Project Number 1454

Subject: Final Submission of Second Work Plan Addendum
Sites 1 through 5, Site Characterization and Evaluation
Naval Aviation Depot, MCAS Cherry Point, North Carolina

1.0 INTRODUCTION

SITE 1 (MCON P-962T)
SITE MAP
MCAS CHERRY POINT, NORTH CAROLINA

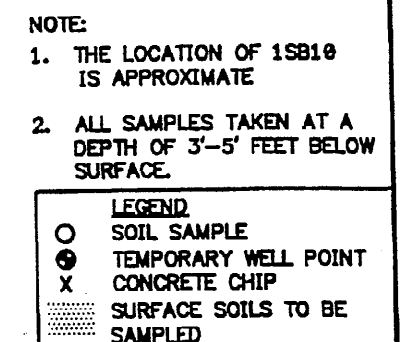
"Discrete surface soil (0-1 foot depth) samples will be taken at sample locations SB01 through SB10, and SB13. Locations SB01 through SB10 will be analyzed for TCL pesticide/PCBs in order to determine the local concentrations of pesticide contamination which was indicated by composite samples analyzed during the initial investigation. In addition locations SB01, SB05, and SB13 will be analyzed for TCL volatiles, TCL semi-volatiles, TAL metals/cyanide, low/medium/high TPHs, and oil and grease. In addition SB13 will be analyzed for TCL pesticide/PCBs.

Figure 3-1 shows the locations of the soil samples taken during the initial investigation, the maximum depth sampled, areas of proposed excavation, and proposed surface soil sample locations.

FIGURE 3-2

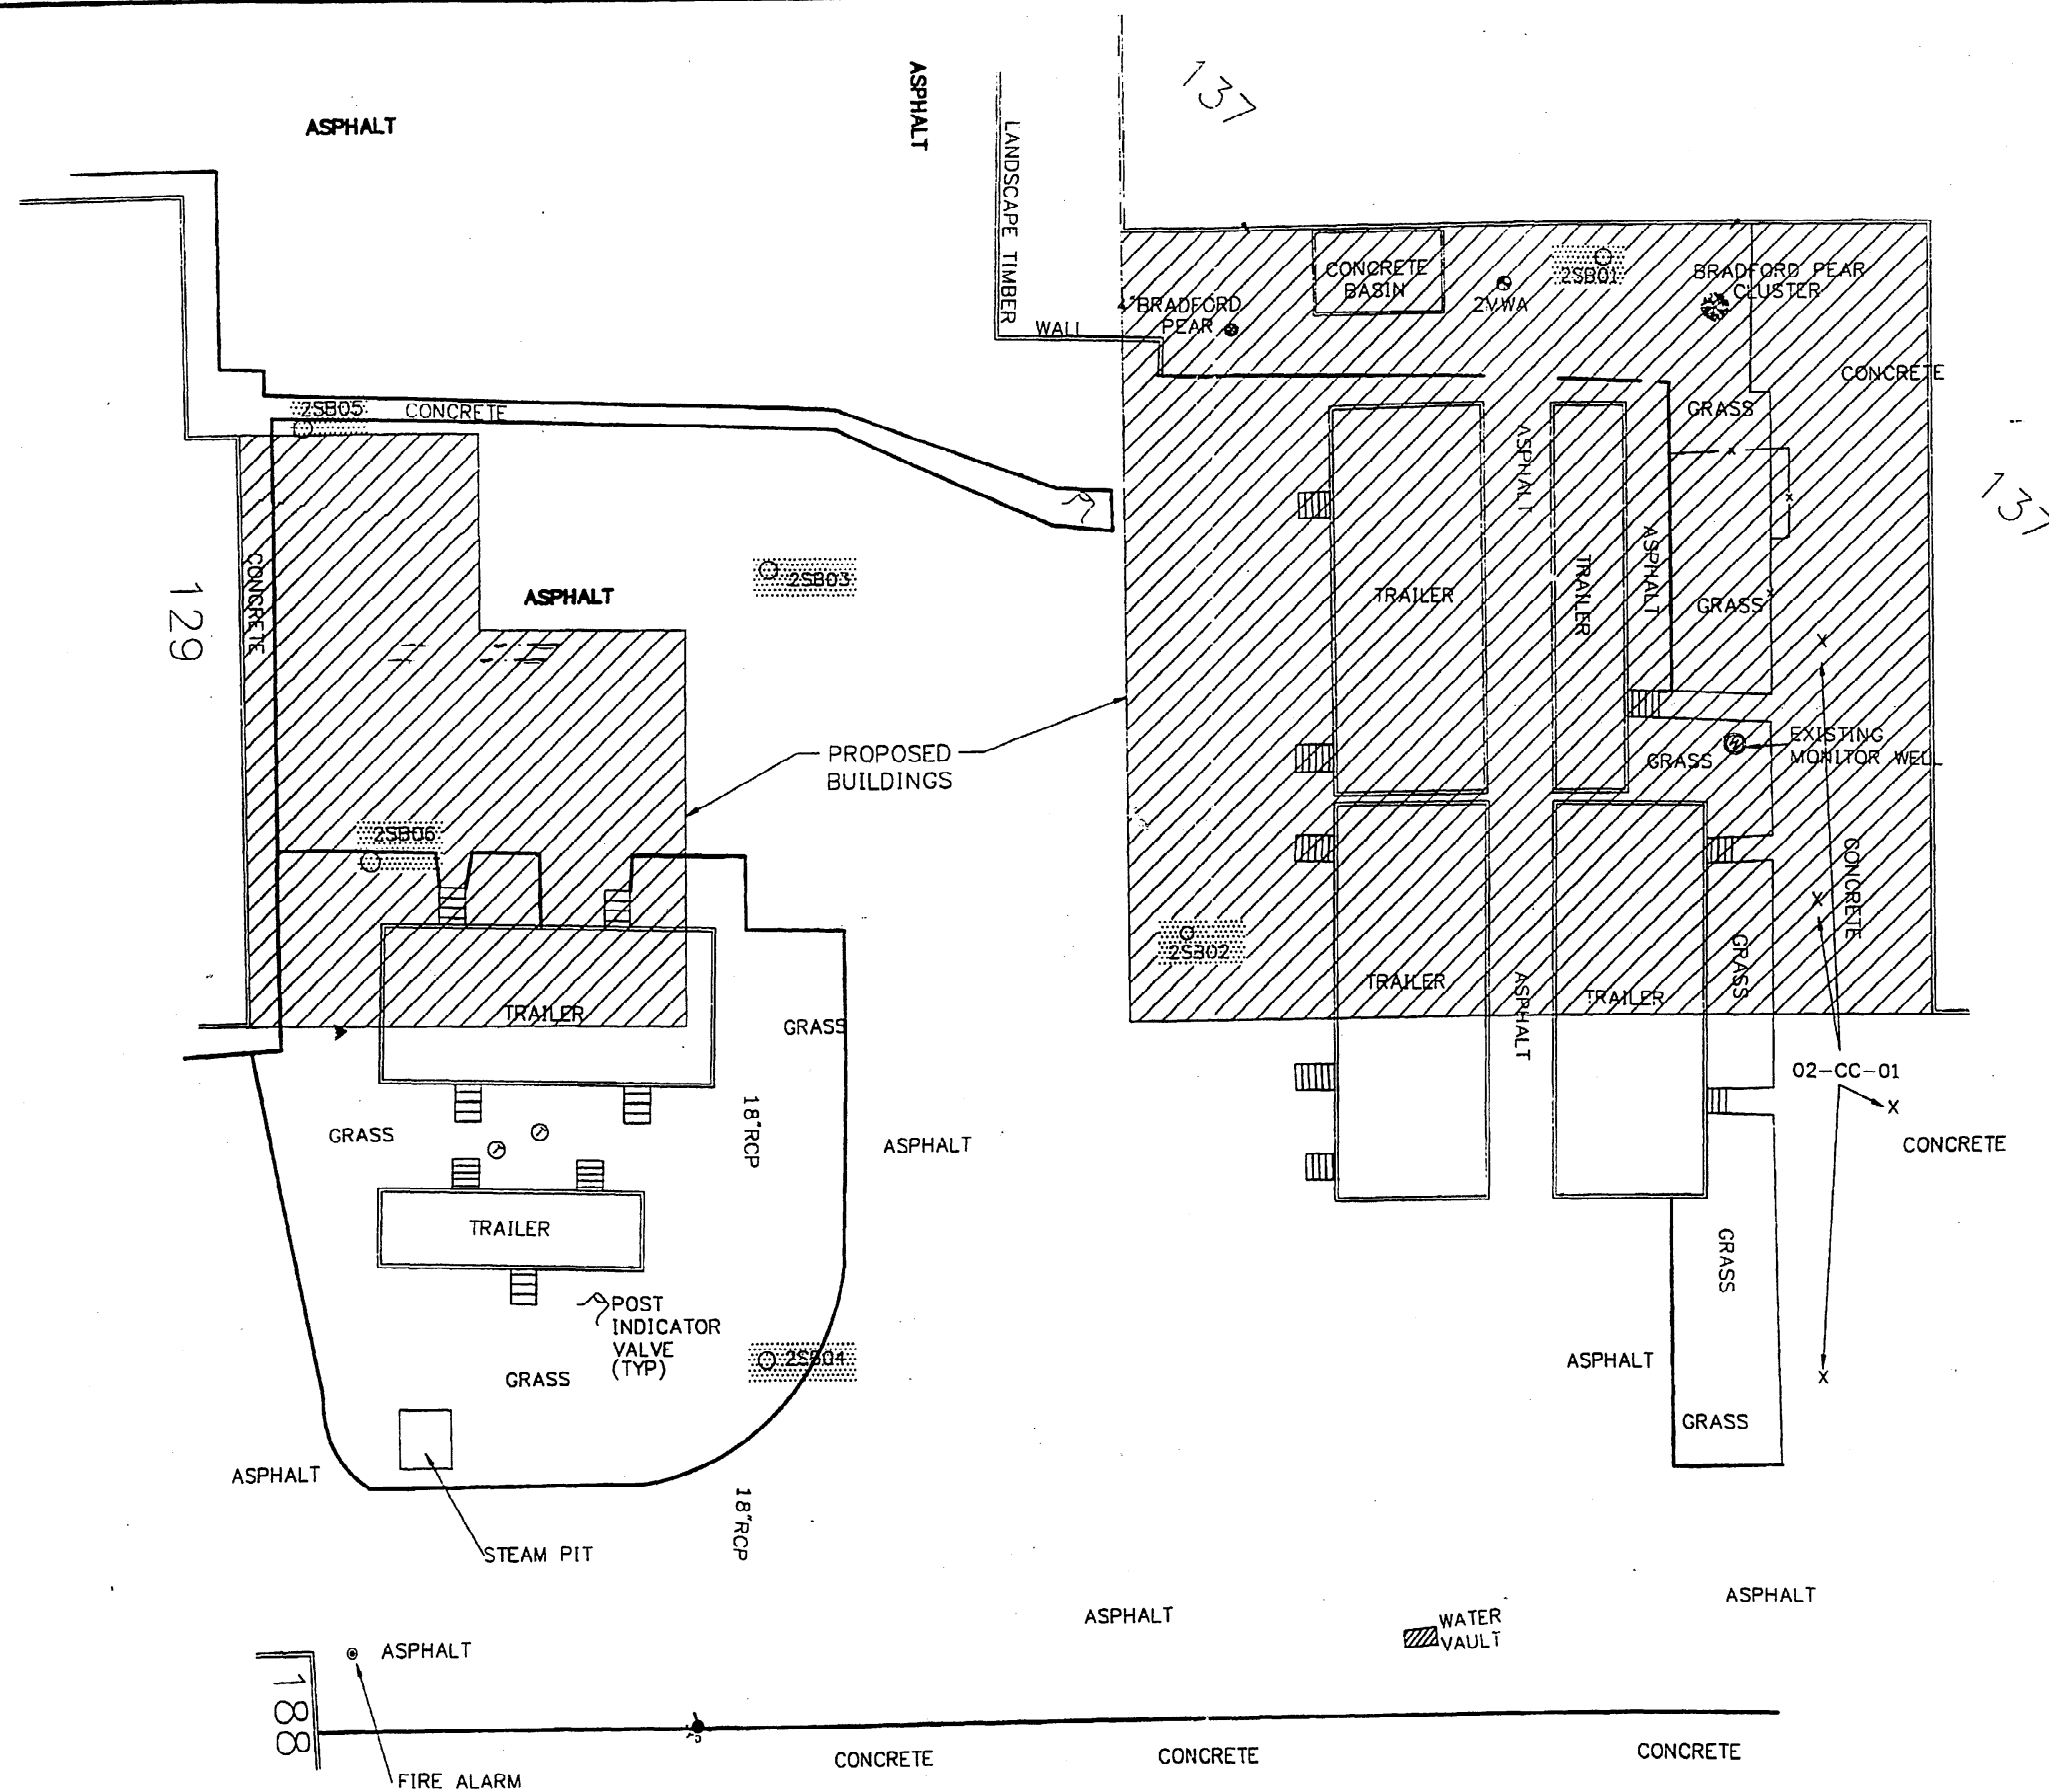
"Discrete surface soil (0-1foot depth) samples will be taken at sample locations SB01 through SB06. These samples will be analyzed for TCL pesticide/PCBs and TCL semi-volatiles in order to determine the local concentrations of PCB contamination which was indicated by composite

samples analyzed during the initial investigation. In addition locations SB01, SB02, and SB06 will also be analyzed for TCL volatiles, TAL metals/cyanide, low/medium/high TPHs, and oil and grease.

Figure 3-2 shows the locations of the soil samples taken during the initial investigation, the maximum depth sampled, areas of proposed excavation, and proposed surface soil sample locations.

FIGURE 3-3

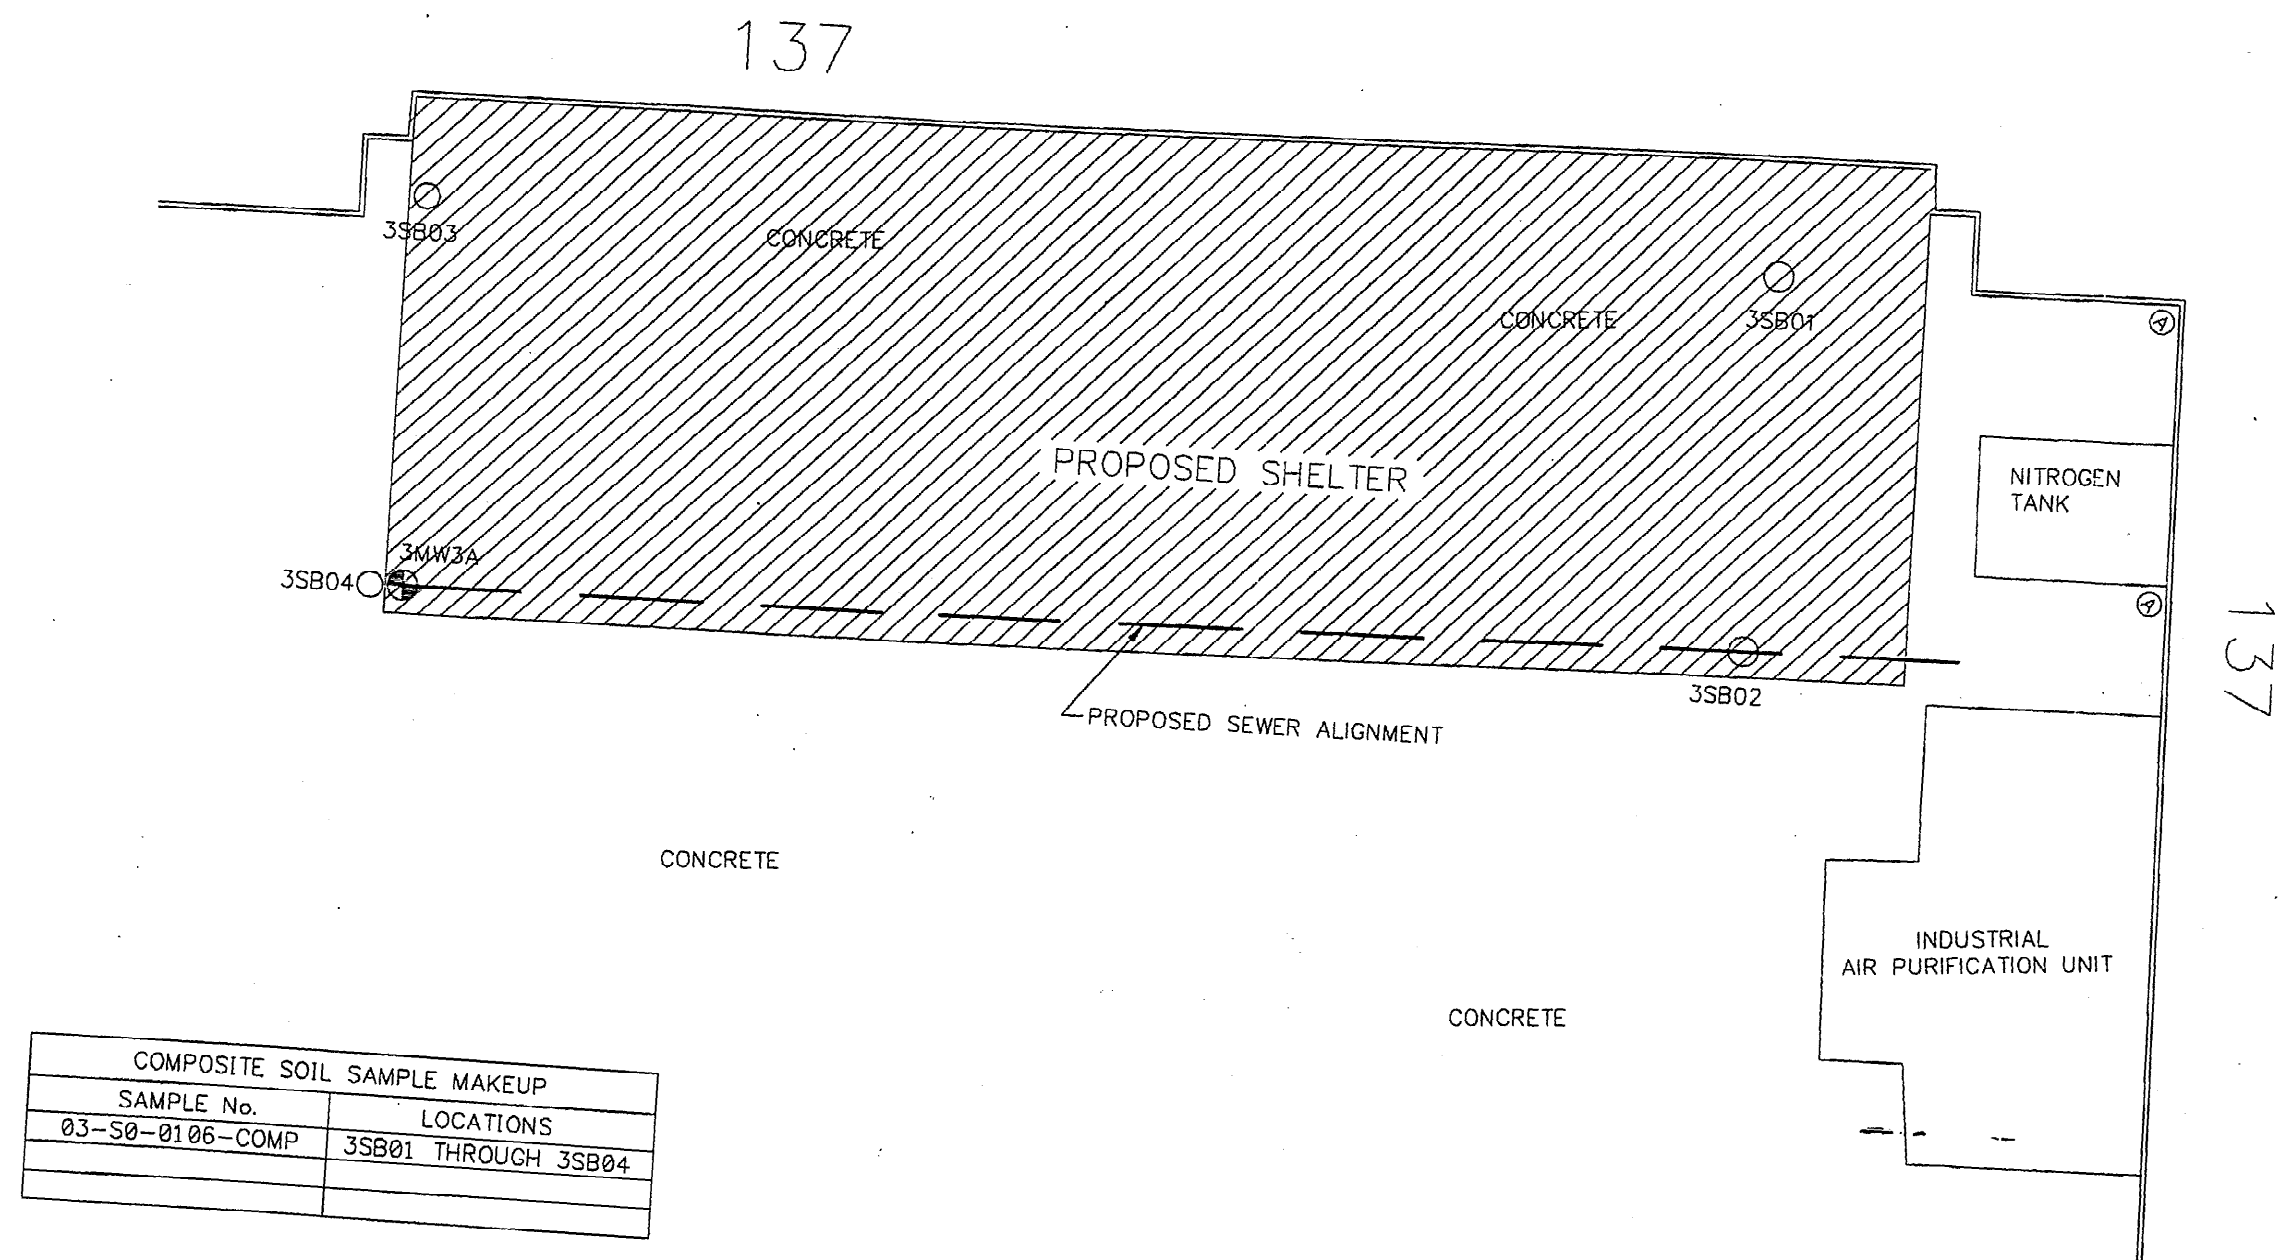
"A discrete surface soil (0-1foot depth) samples will be taken at sample location SB04. This sample will be analyzed for TAL metals only, since the initial investigation indicated no organic contaminants were detected at the method detection limits utilized.

Figure 3-3 shows the locations of the soil samples taken during the initial investigation, the maximum depth sampled, areas of proposed excavation, and proposed surface soil sample locations.

FIGURE 3-4

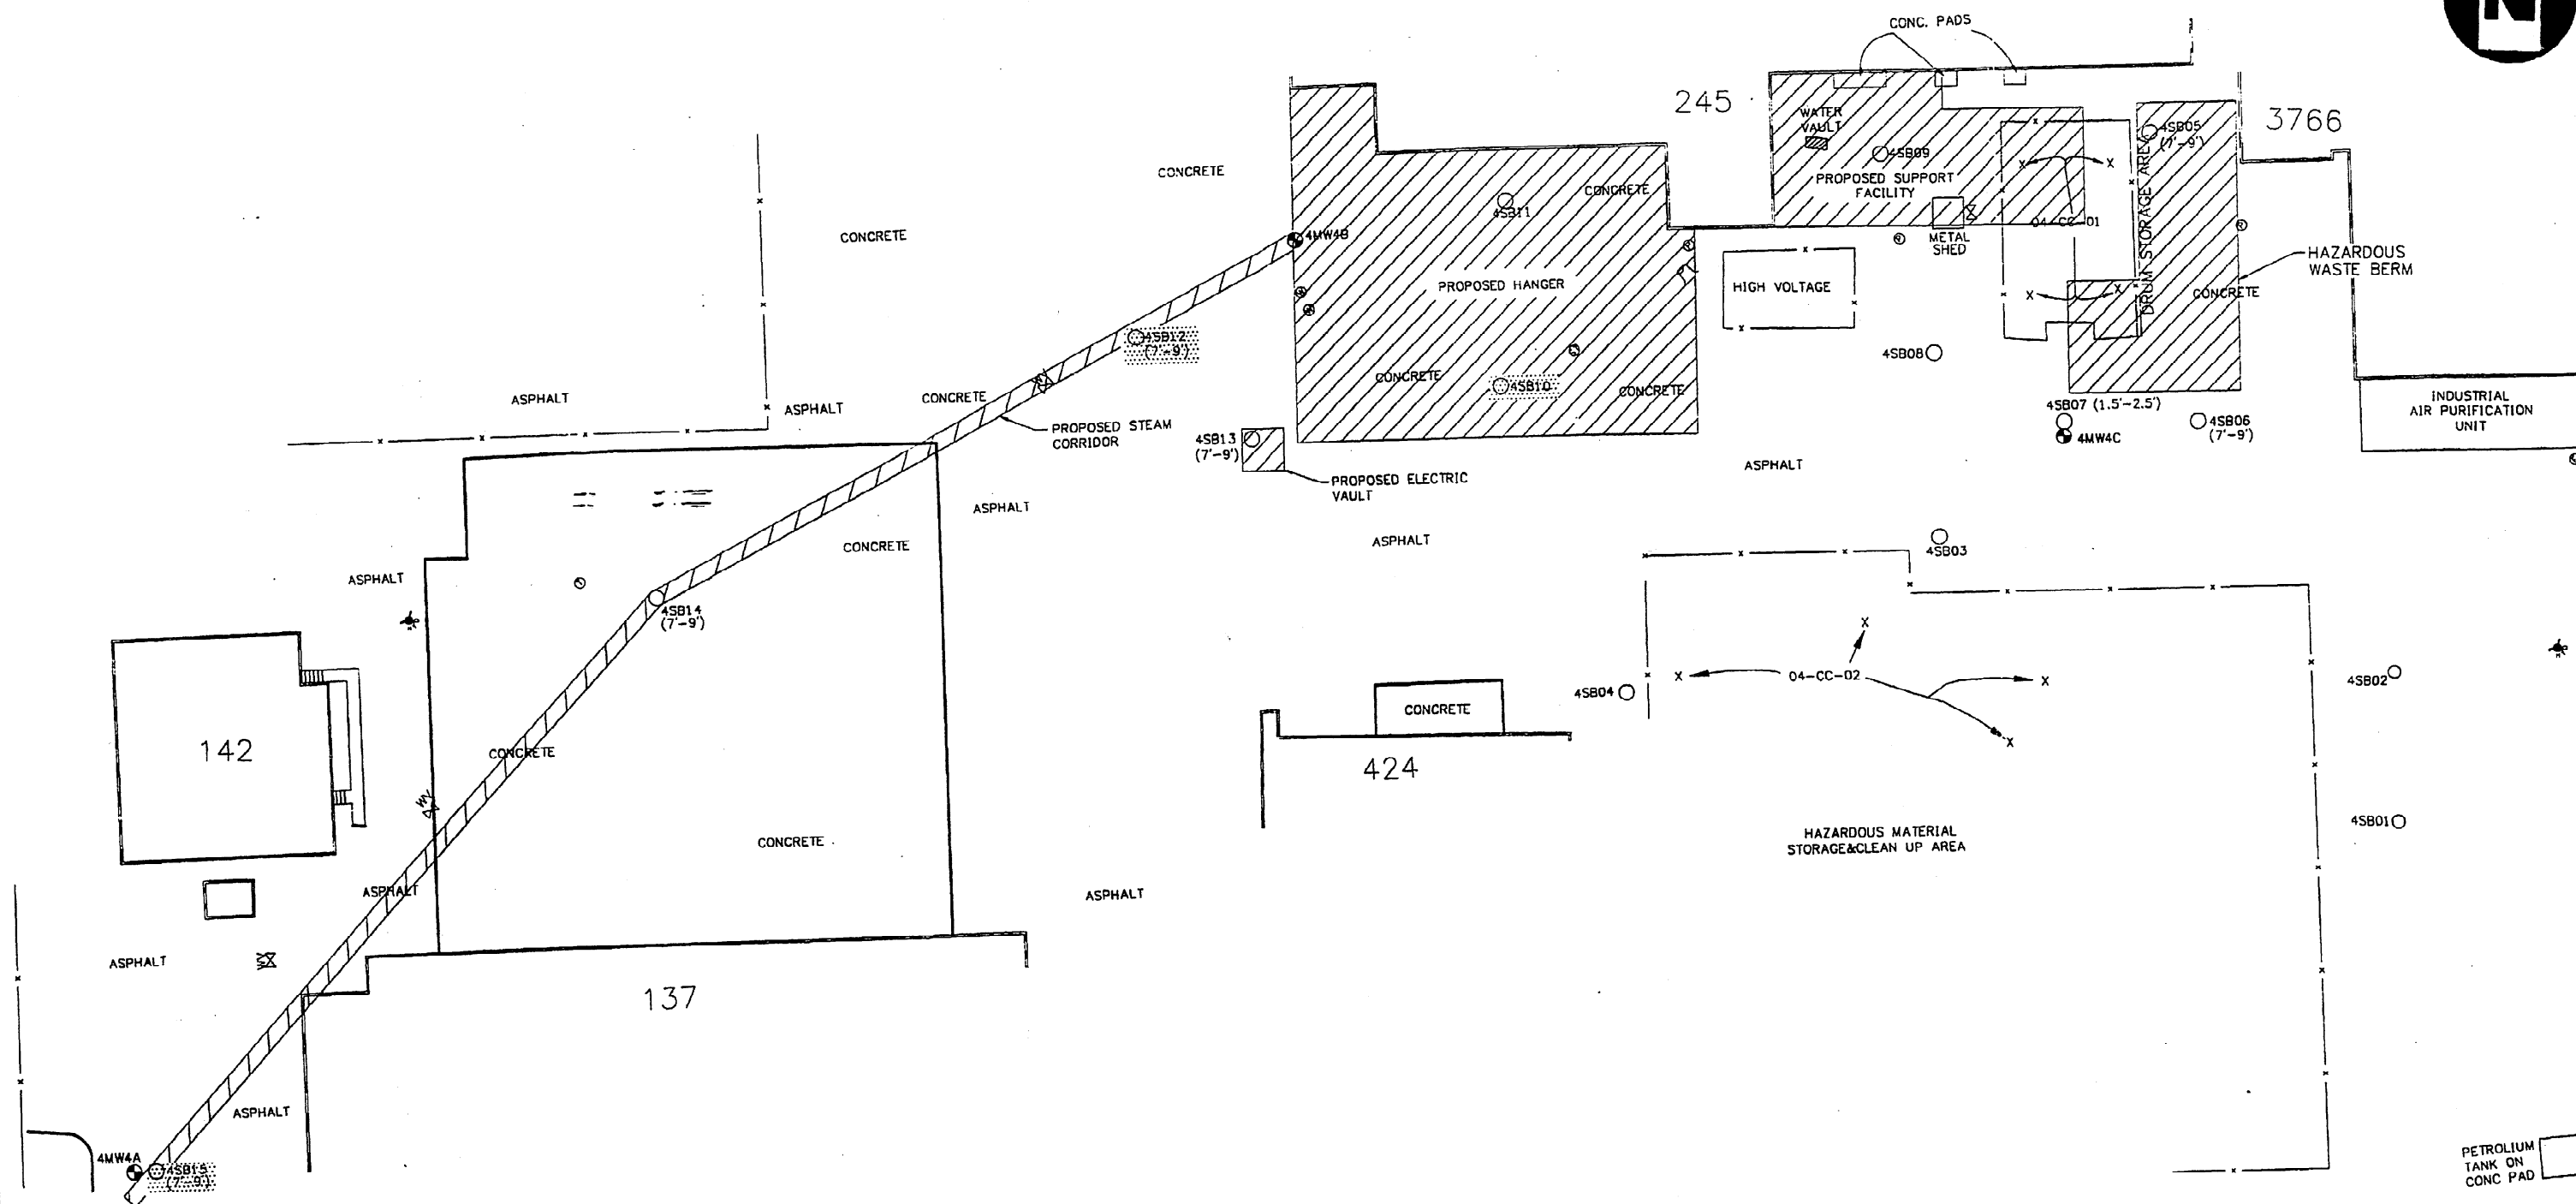
"Discrete surface soil (0-1foot depth) samples will be taken at sample locations SB10, SB12, and SB15 and will be analyzed for TCL volatiles, TCL semi-volatiles, TCL pesticide/PCBs, TAL metals/cyanide, low/medium/high TPHs, and oil and grease.

Figure 3-4 shows the locations of the soil samples taken during the initial investigation, the maximum depth sampled, areas of proposed excavation, and proposed surface soil sample locations.
